**Visions In Education**  
**TENANT IMPROVEMENT PROJECT**  
**Project # 26-01**  
**ADDENDUM NO. 2**

February 24, 2026

2.3 REPLACE the following sheets:

## DEMO/NEW FLOOR PLANS, EXITING PLAN AND SCHEDULES

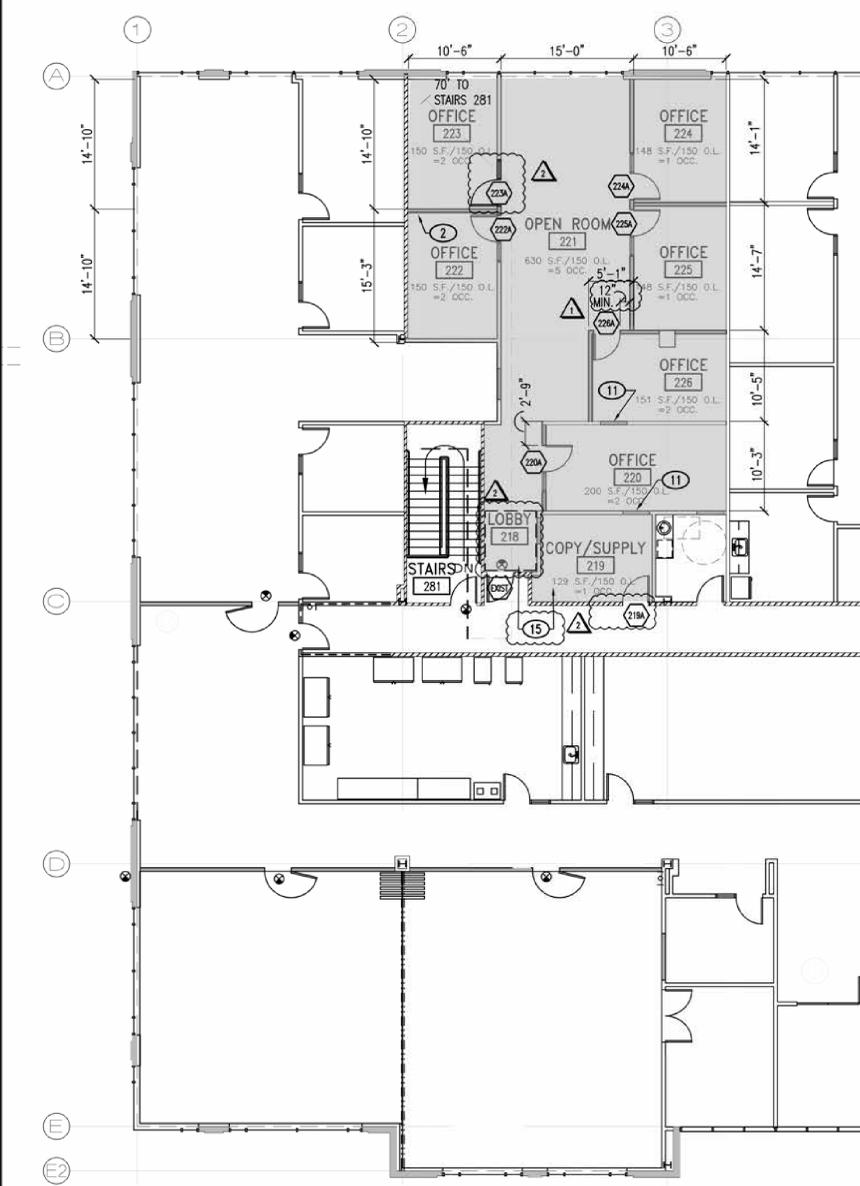
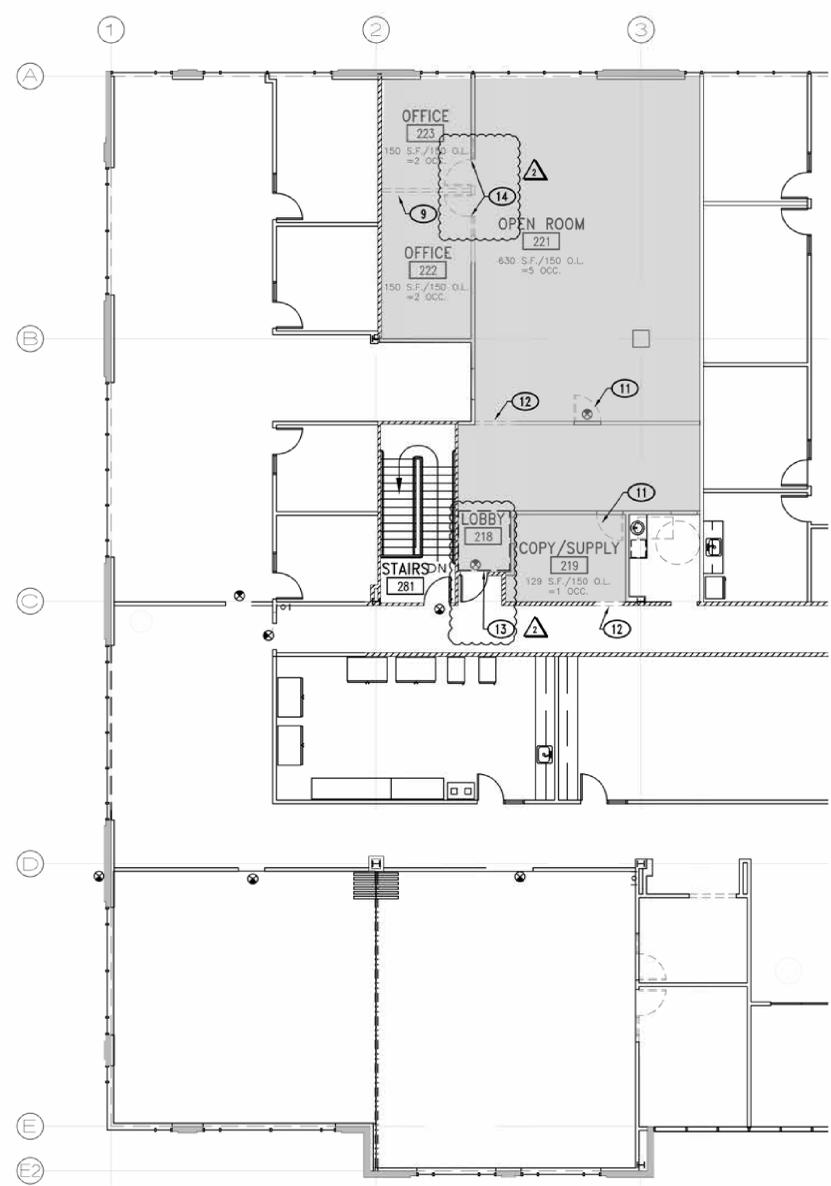
**QUESTIONS #23:** Please clarify what, if any, attic stock is available for our use.

Please provide specifications, if available, for the carpet, ceiling tiles, doors, hardware and any other finishes we are to provide.

There is no finish schedule for what is wanted for flooring, paint colors, T-bar ceiling, door hardware etc. Please provide a spec so we know exactly what kind of materials are wanted.

**QUESTION #33:** Please clarify the only interior work is shaded grey on A2.1. There is conflict in what appear to be new walls on gridline C and D.

**Response:** The Owner has approximately 144 SF of carpet tiles that can be used for this project. See attached Phase 1 for submittal products (Attachment 2.13) and Sheet A2.1 Addendum #2. Owner has carpet tiles, ceiling tiles and paint that can possibly applied to this project. See revised Sheet A2.1 addressing hardware revisions.

**Response:** Only within the shaded area on Sheet A2.1 is the scope of work for this project.

**NEW REFLECTED CEILING PLAN**

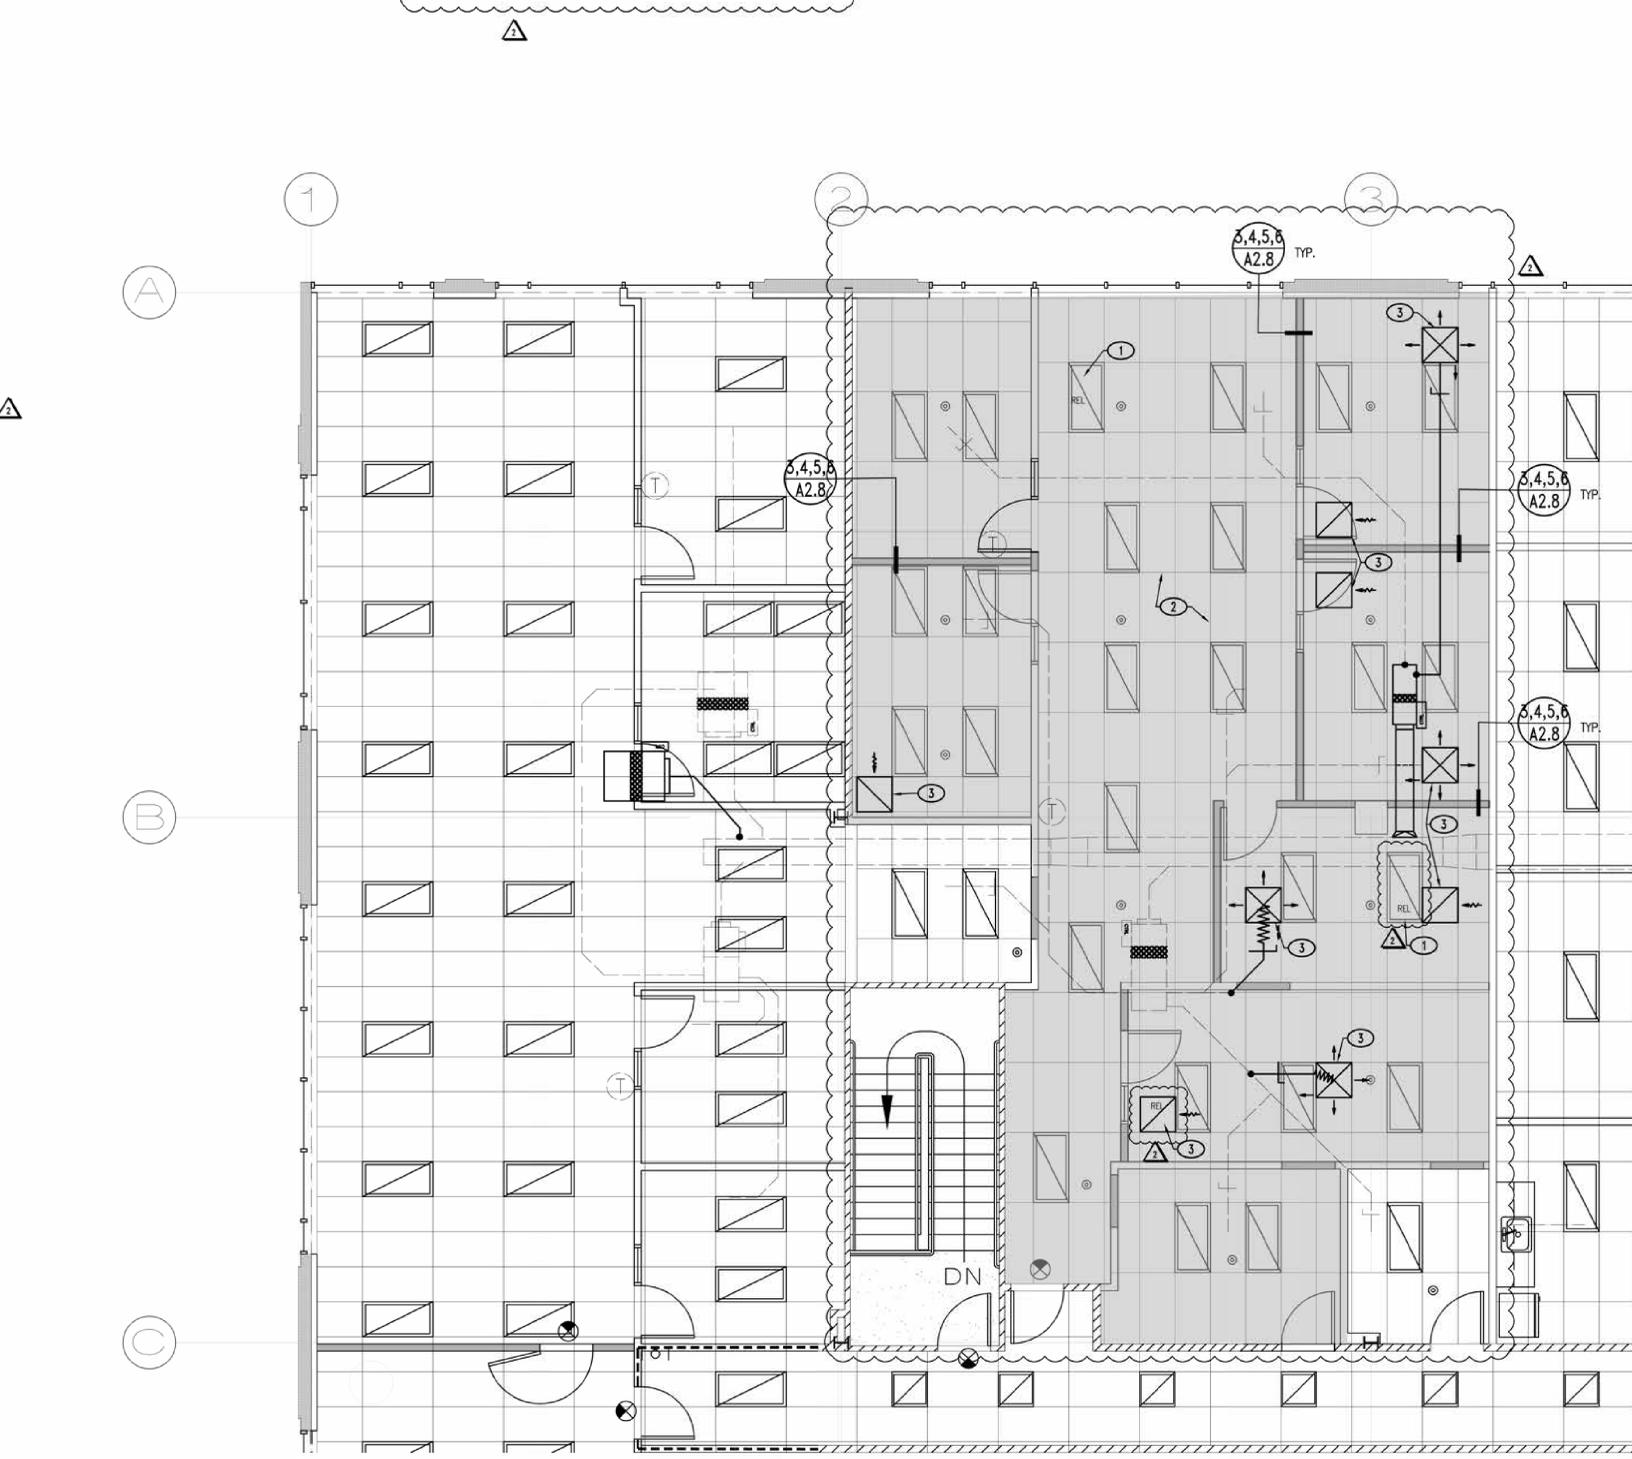
**QUESTION #31:** On sheet A2.8 is there work in the clouded area above the women's restroom? Gridlines C/5.

**QUESTION #32:** Is there any work for notes 3 and 6 on A2.8? See gridline C. If yes, please provide note 6.

**QUESTION #34:** Please provide the deck height for full height walls and kickers.

**QUESTION #38:** Please clarify if detail 2 on A2.8 is new, as noted, or existing.

**Response:** No

**Response:** See revised detail 3/A2.8 for full height wall for scope of work.

**Response:** Bottom of deck is 12'-0". Walls to extend to the underside of the deck per attached revised detail 3/A2.8.

**Response:** Detail is for any modifications required to existing suspended ceiling in coordination with new work.

**M2.1**

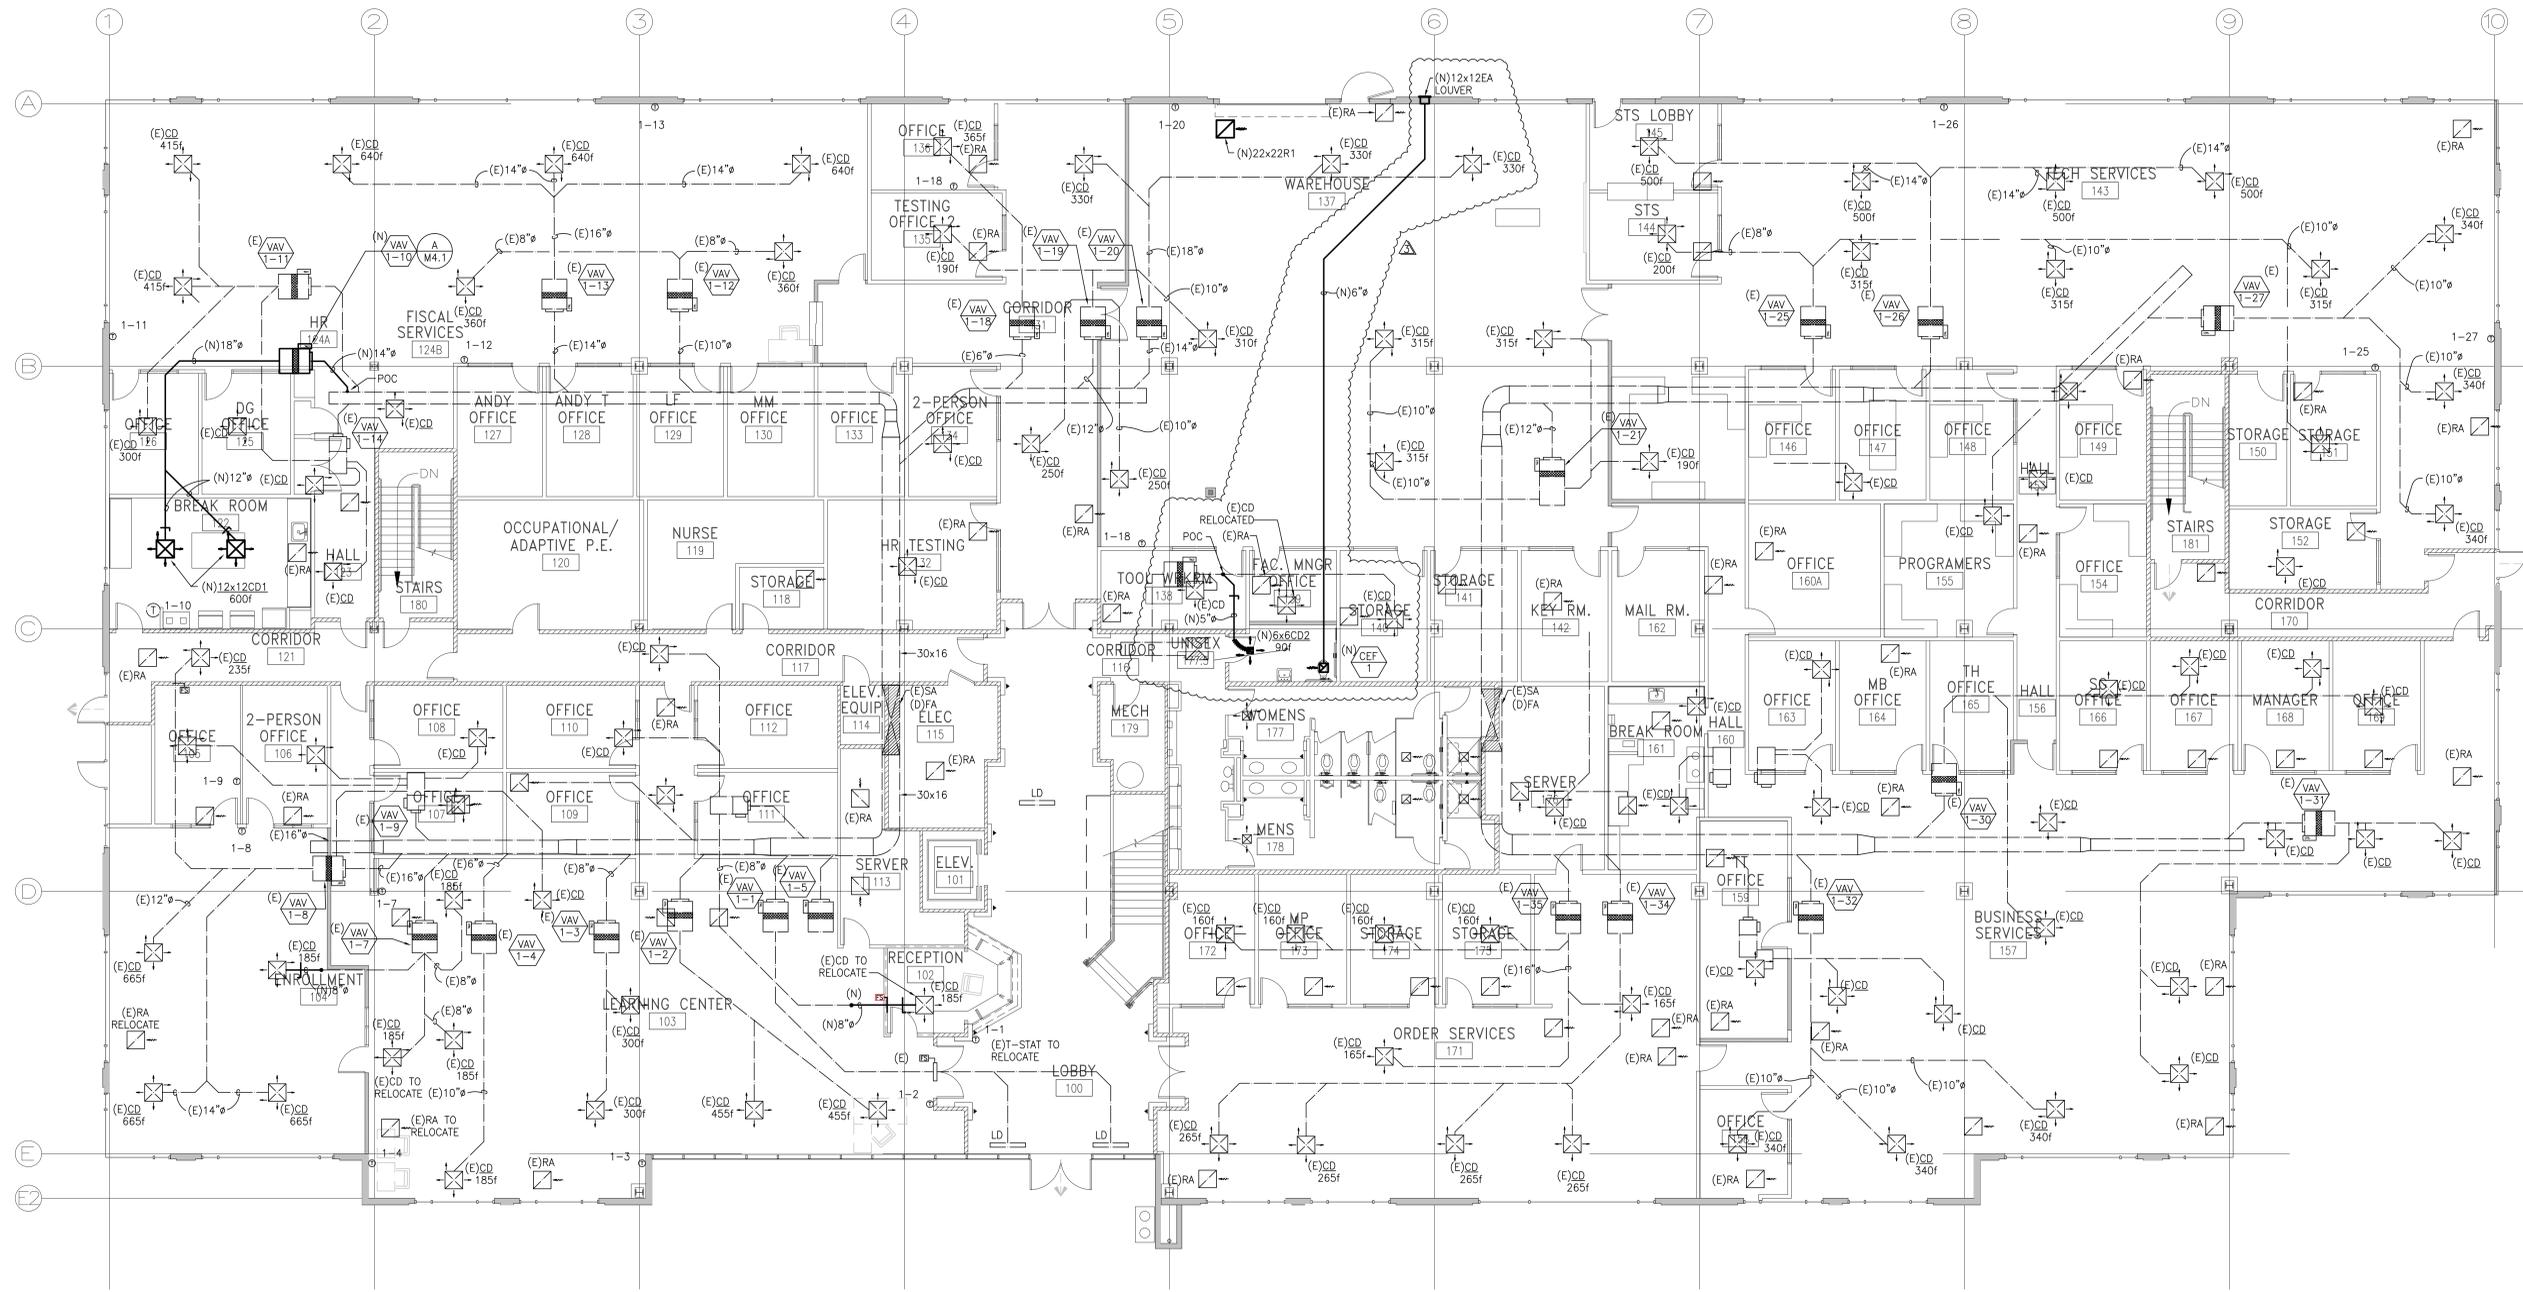
**QUESTION #42:** On the VAV schedule one of the new boxes on page M0.1 of the drawings is listed as 1-10 which would indicate it is on the first floor.

**Response:** 1-10 is existing, not new; that is the existing designation. The new box added is 2-33, which is clouded with DELTA-4 is in the scope of work. As this is change to existing project the other box listed on the schedule is for the previous project.
